CITY OF PORTLAND

BUILDING PERMIT

Job ID: 2012-05-4016-NEWCOM

**RE: University of New England – Patient Care Center
Application #2012-483; CBL 145-B-024
1 College Street
Response to Staff Comments**

DESIGN: DDTC	PROJECT: PATIENT CARE CENTER
DRAWN: TMS	UNIVERSITY OF PORTLAND, MAINE
CHECK: TMS	STUDENT CENTER, PORTLAND, MAINE
DATE: JAN 2022	GRADING, DRAINAGE & EROSION CONTROL PLAN
SCALE: 1" = 20'	
PROJ. NO.:	
DRAW. NO.:	
REV.:	C-102

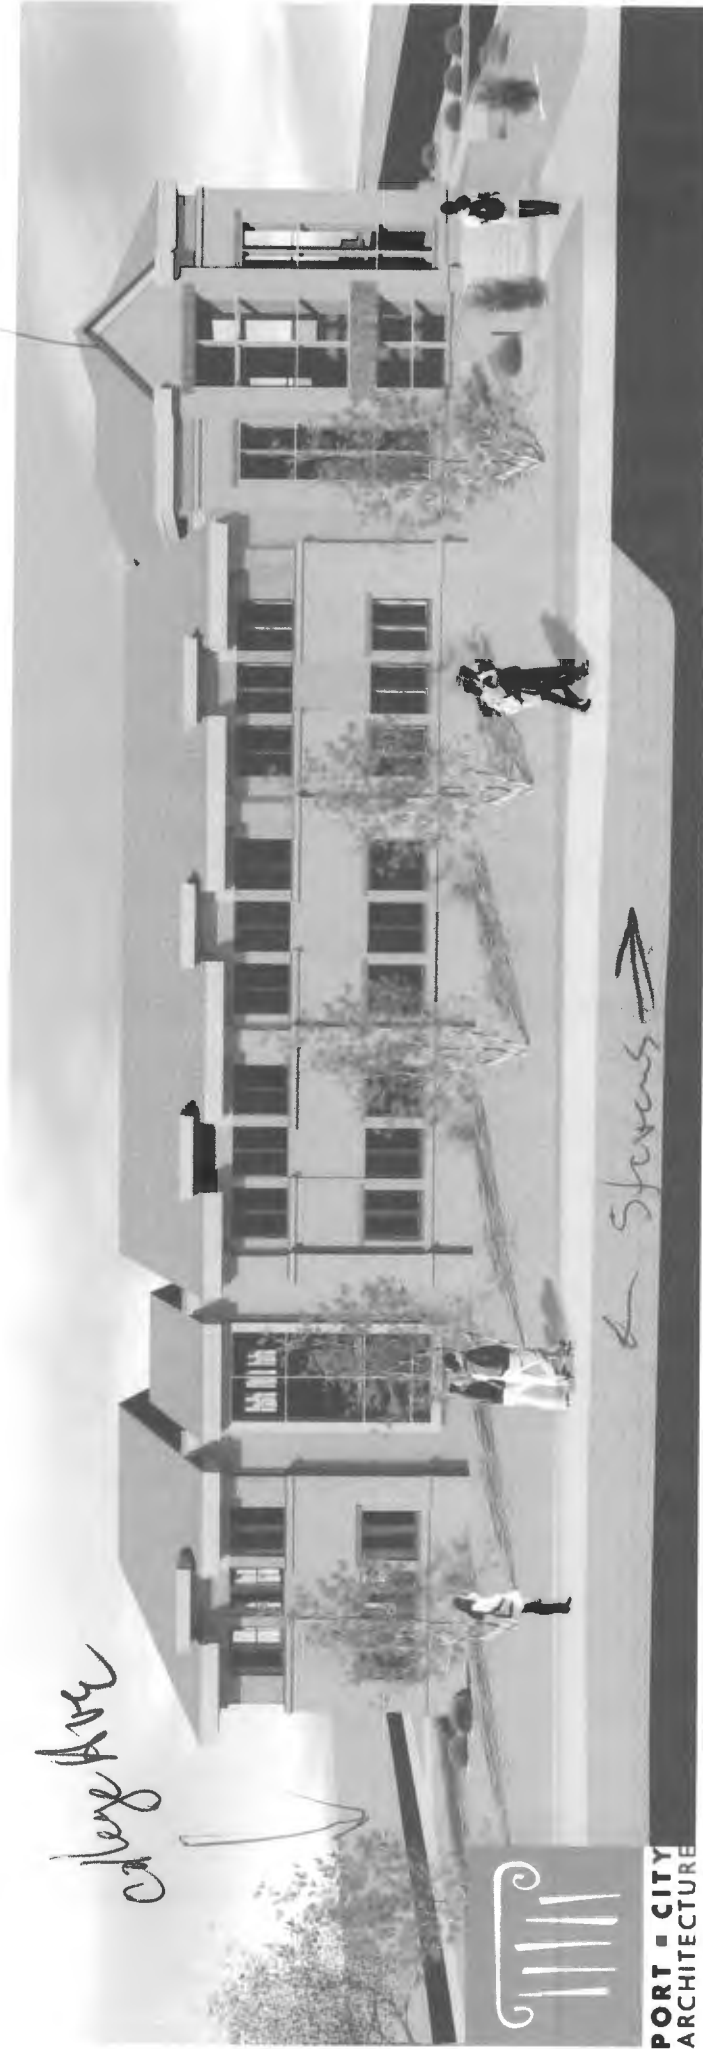
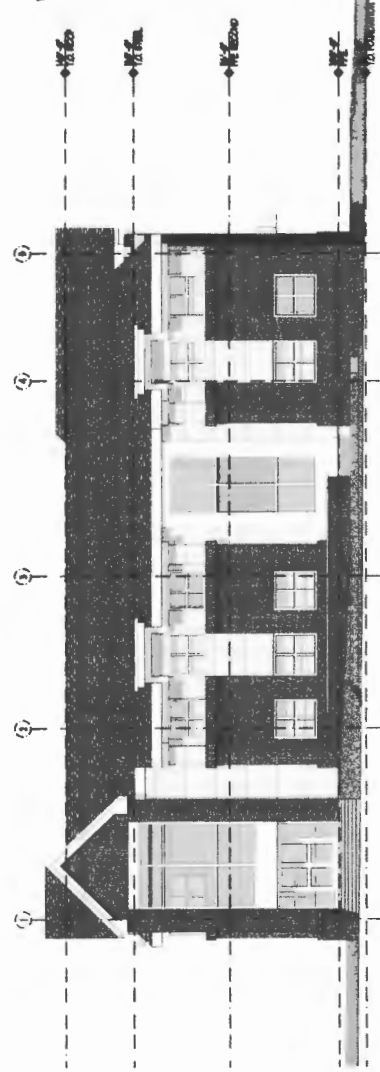
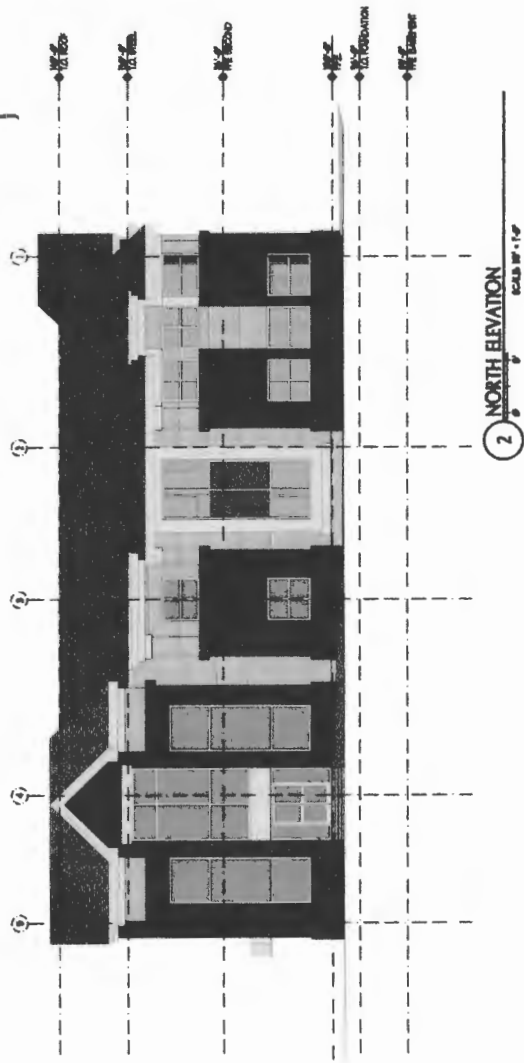
- a. *Basic Standards: The applicant has provided sufficient erosion and sedimentation control notes and details; however, the site plan should show the location of sediment barriers, stabilized construction exit(s), and catch basin inlet protection. In addition, the applicant must provide an Inspection and Maintenance Plan for their proposed stormwater management systems in accordance with Chapter 500 and City Code of Ordinances Chapter 32 guidance.*

need grade elevations and
study

main entry 2 story college

Drawing C-102 now shows the catch basin inlet protection. The site likely will be internally drained, similar to the College of Pharmacy. The plans do provide for the installation of a filter barrier if it is required but it is not shown on the drawings. We have not shown a stabilized construction entrance. It has been our experience with construction projects on this campus, that tracking onto Stevens Avenue has not been problematic. Existing pavement will remain to the extent possible, and the existing pavement and underlying gravels will be stable.

1 PARTIAL EGRESS PLAN
 0 8'-0" SCALE: 1/8" = 1'-0"

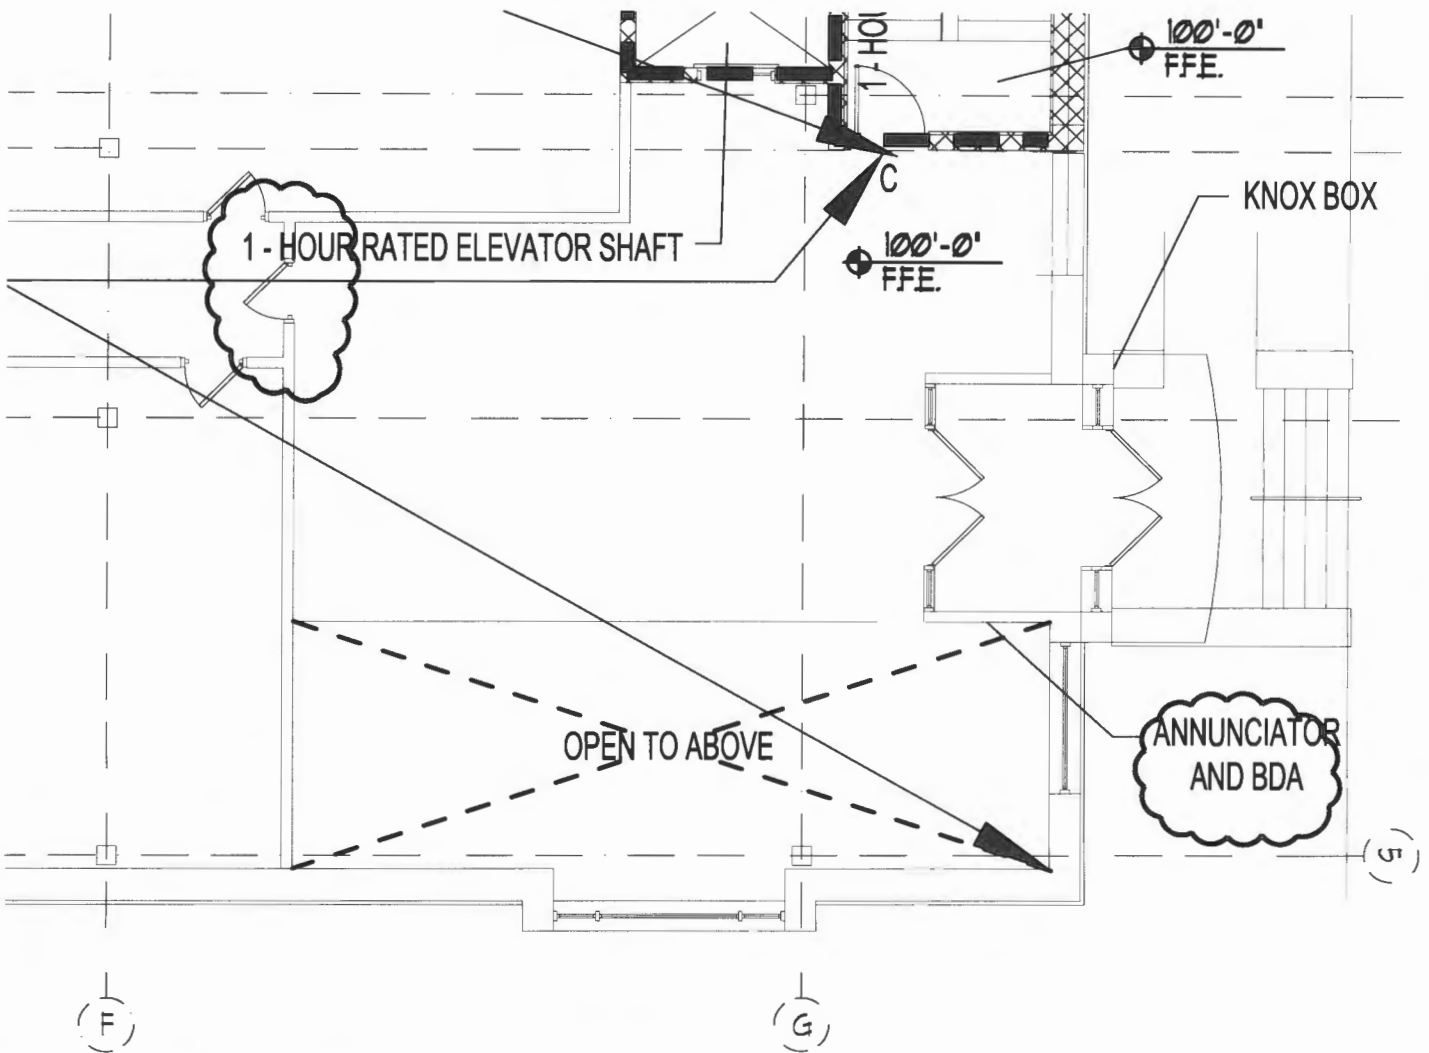
Sec. 14-425. Projections in required yard areas.

Any yard may be occupied by a one-story entrance porch not enclosed, with or without a roof, if the area of the porch does not exceed fifty (50) square feet nor the projection from the building exceed six (6) feet. A basement bulkhead of similar size, but not more than twenty four (24) inches in height, is also permitted. A cornice eave, sill, canopy, chimney, or other similar architectural feature, but not including a bay window, may project into any required yard a distance of not more than two (2) feet.
